APPLICATION NO.	FILING DATE	FIRST NAMED INVENTOR	ATTORNEY DOCKET NO.	CONFIRMATION NO.
09/974,777	10/09/2001	Max Schaldach	7040-45	6887

Office Action Summary

SCHALDACH ET AL.

FIG. 1

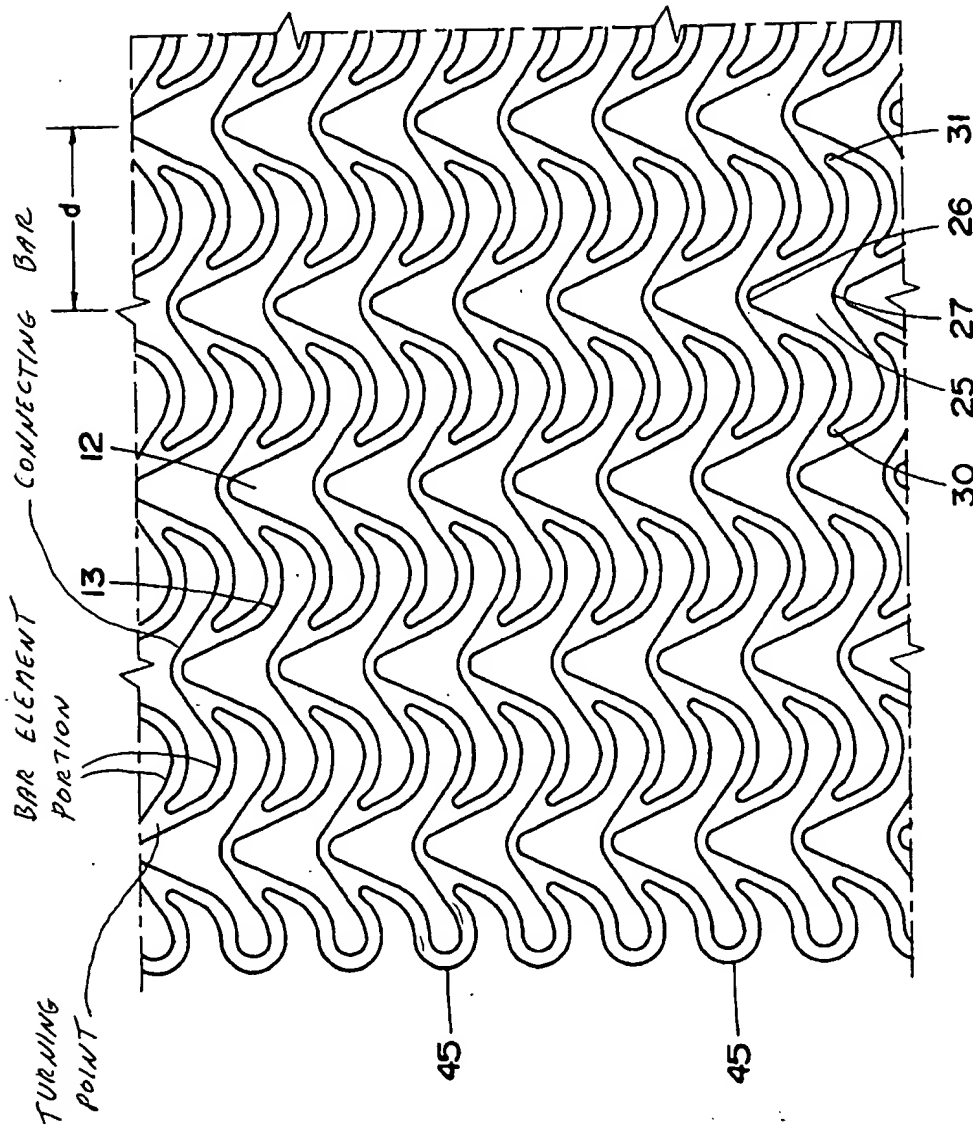
Claims 1, 2, 5, 6, 9, 10, 20, 21, 23, 24, 26, 27, 47 and 48 are rejected under 35 U.S.C. 102(e) as anticipated by or, in the alternative, under 35 U.S.C. 103(a) as obvious over Alt (DE 19834956). Alt, as shown the attached appendix (which is based on the equivalent U.S. Patent 6,398,805 only because this figure is clearer than the equivalent figure in the foreign patent), discloses bar elements and connecting bars wherein the first and second bar element portions are entirely concave over the entire length of the bar element portion as now claimed. Alternatively, it would have been obvious that the Alt first and second bar element portions are entirely concave over the entire length of the bar element portion since figure 1 appears to show this. As to claim 5, the bar element portions are inherently adapted to keep stresses below a plastic deformation limit upon

Applicant's arguments filed August 8, 2005 have been fully considered but they are not persuasive. All of the Alt bar element portions extend curvedly in the same manner. That is, they all extend in a concave arcuate manner. The phrase in claim 1, lines 12-13, "curvedly in an identical concave or

convex arcuate manner" does not require the radius of curvature of the bar element portions to be identical. Nor does it require the length of the bar element portions to be identical. If applicant wishes the claim to require that the shape and size of all of the bar element portions in the first annular support member be identical, then this limitation should be incorporated into the claim.
